**NSLPP MEETING HELD ON 06/09/23****Attachments:**

**ADDRESS/WARD:** Unit 6/19 Belmont Avenue, Wollstonecraft**APPLICATION No:** DA 112/23**PROPOSAL:** Alterations and additions to Unit 6 within an existing residential flat building including garage conversion and additions to roof terrace**PLANS REF:**

**OWNER:** R Rosenbach**APPLICANT:** Performance Building Consultants**AUTHOR:** Miguel Rivera, A/Team Leader (Assessments)**DATE OF REPORT:** 9 August 2023**DATE LODGED:** 3 April 2023**RECOMMENDATION:** Approval

**Figure 20: Elevation showing maximum building height line (in blue), proposed height variation (shaded in red) and height compliance (shaded in green) of the proposal**

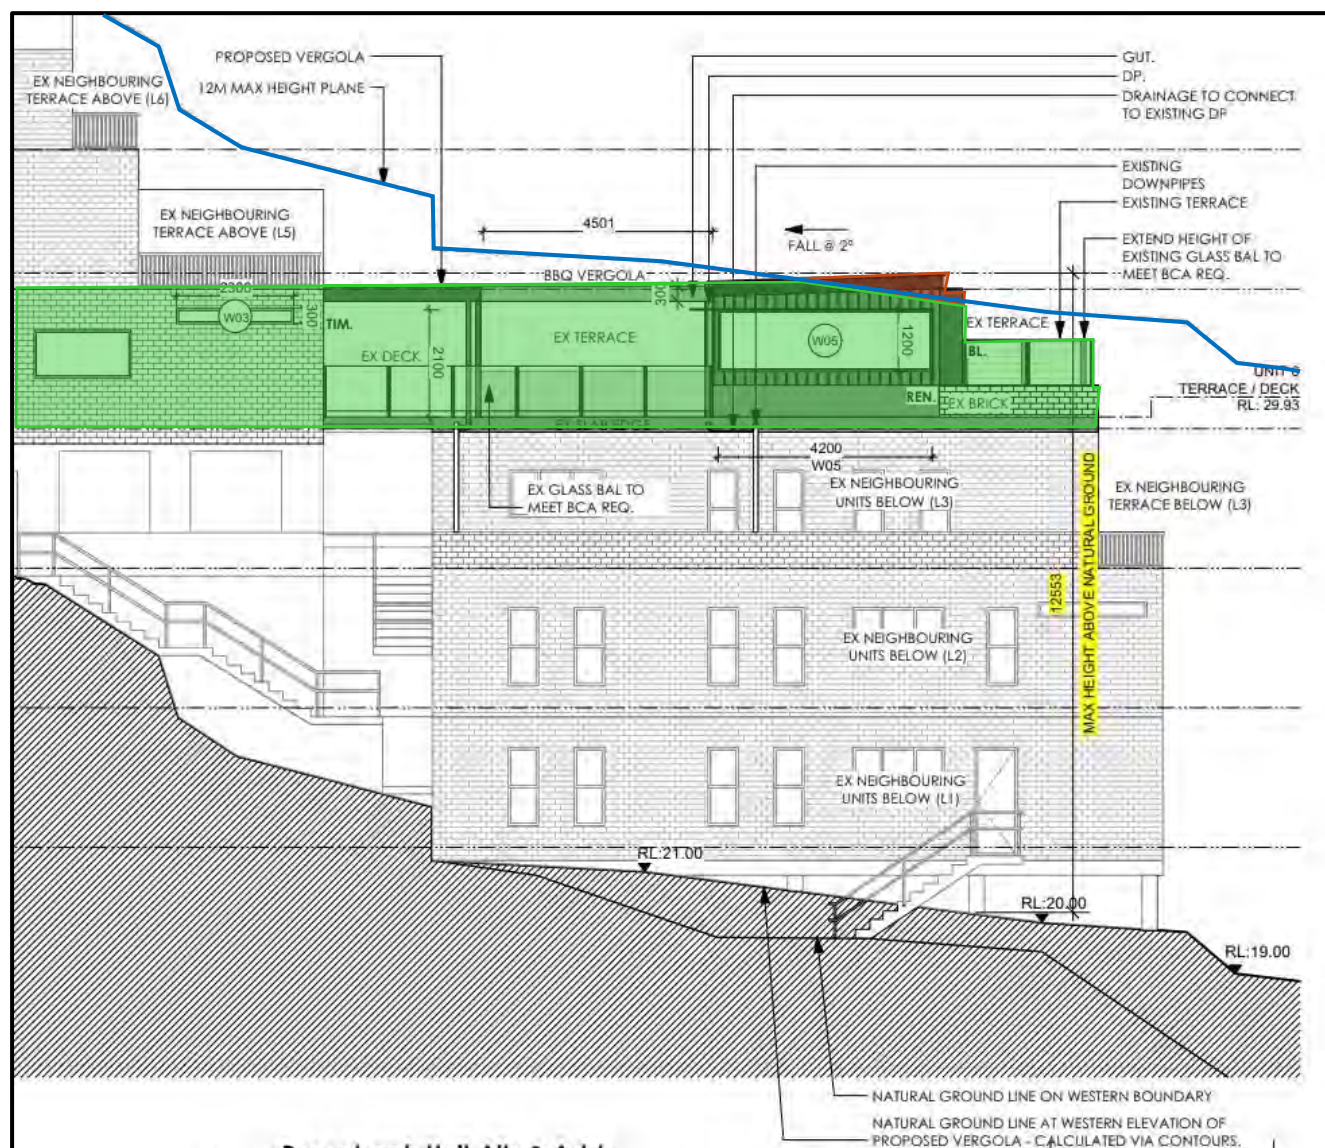
The proposed development involves a maximum height of 12.55m, which is caused by a small portion of the new enclosed structure (refer to Figure 20). The proposed height represents a 0.55m or 4.58% variation to the maximum height of buildings development standard under Clause 4.3 of NSLEP 2013.

An elevation showing the height variation and compliance of the proposal is shown in Figure 20 below.

**Building height plane and setback diagram (non-compliant portions shaded in green) and proposed variation circled in purple**

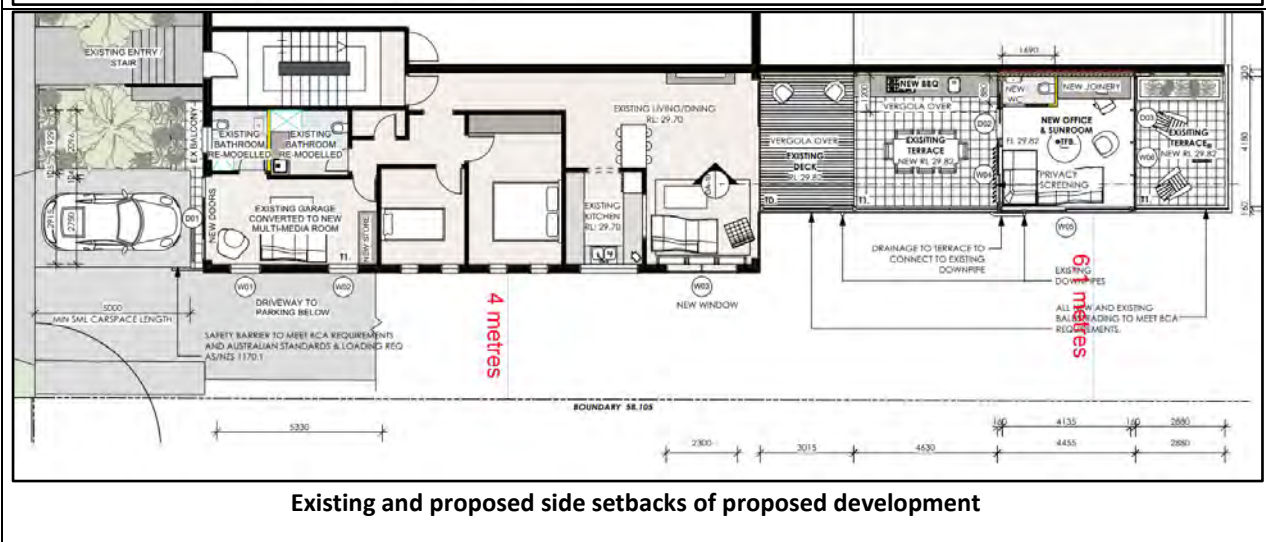
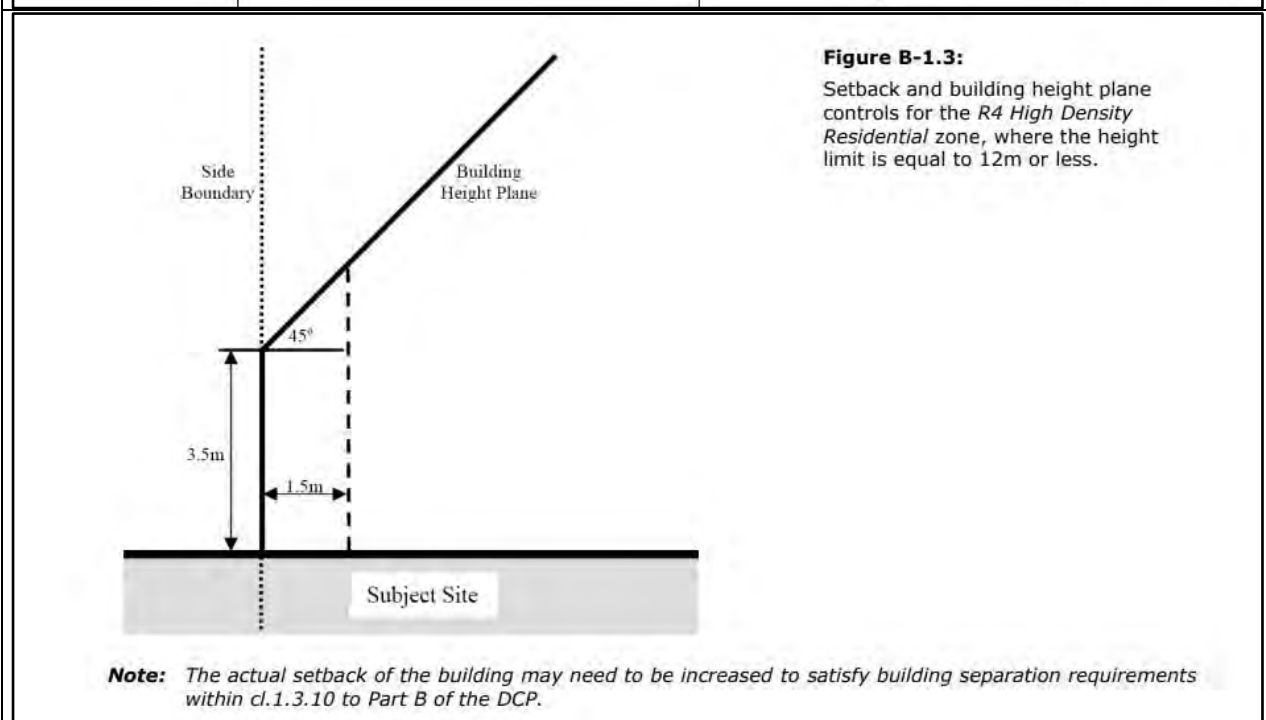
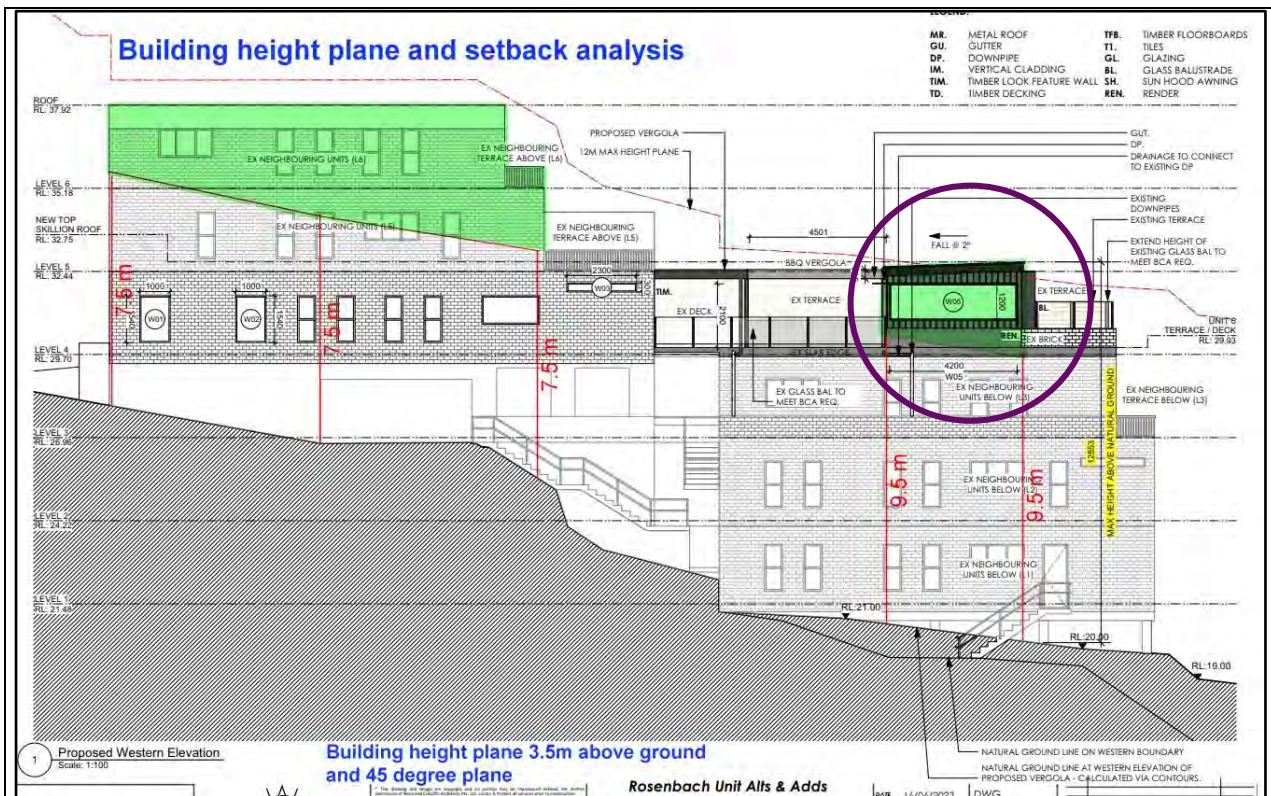
<b>Setback – front</b>	Yes	Refer to ADG table.
<b>Setback – side</b> <b>Setback requirements – see below table and diagram</b>	No – demonstrates merit	<p>In general, the guidance controls under ADG override the DCP setback controls; however, consideration has been made with regard to the DCP as follows:</p> <ul style="list-style-type: none"> <li>• The majority of the front portion of the existing building does not comply with the setback control.</li> <li>• The setbacks of the existing building remain generally unchanged. The only element triggering review is the new enclosed structure, which will sit on an existing roof terrace. This structure will have a setback of 6.1m from the side boundary – maintaining the current setbacks of the roof terrace and the lower residential levels of the building. The introduction of the enclosed structure is not considered to result in substantial visual bulk, scale and massing to the existing building.</li> <li>• The proposed setback variation will not result in substantial nor adverse impacts in terms of view loss, amenity, privacy and streetscape.</li> <li>• The proposed side setback is consistent with and reflective of the development pattern and streetscape of the immediate area – which is characterized by staggered, residential flat buildings that step down with the sloping topography of sites with outlooks towards bushland reserve.</li> </ul> <p>On balance and with regard to the above aspects, the proposed setback is considered reasonable and acceptable and demonstrates compliance with the ADG. As such, a variation to the DCP control is considered acceptable and reasonable.</p>

**Figure 21: View towards upper units within building (Units 8, 9 and 10) and the roof terrace of the adjoining residence (Unit 7) (shaded in yellow)**

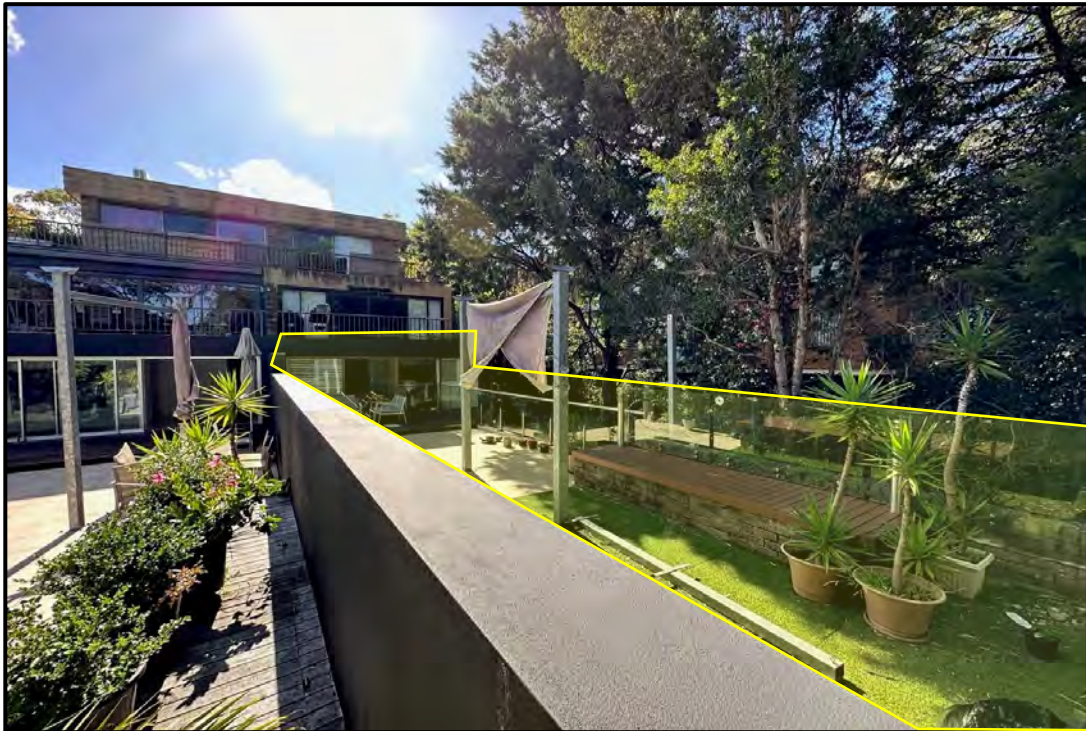
As mentioned previously, the urbanized setting and context of the site features exposed balconies, roof terraces and openings/windows of staggered and high residential flat buildings; many of which generally face the bushland reserve and adjoining buildings. Residences within the immediate locality typically, would overlook each other and are designed to capture pleasant outlooks and distant views of the horizon and trees. This setting and context are demonstrated in Figures 21 and 22 below.

It is noted that the roof terrace of Unit 6 is currently exposed to overlooking from some neighbouring properties and the upper units within the complex (refer to Figures 22 and 23). The provision of additional roofed and enclosed structures to this space will facilitate an improved shared privacy and amenity for the residence and amongst neighbours. These components would screen some of the existing views to neighbours from the terrace and vice-versa.
